Kansas Department of Agriculture
 Division of Water Resources
CHANGE: P/D WORKSHEET

RE: Change in Point of Diversion Water Right, File No 28833

RE: Application for Change in Point of Diversion
Water Right, File No. 28833

GMD3 Change Review

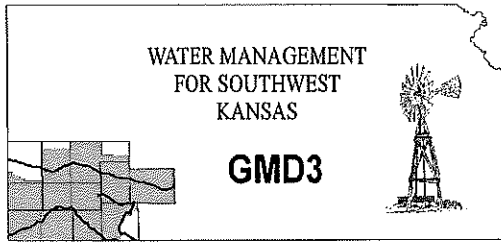
LV Farms has applied to relocate the well authorized by the above water right number. There are four neighboring wells within ½ mile of the requested.

We are delaying action for 15 days on the change application to allow you time to review and provide a recommendation if you feel one is warranted.
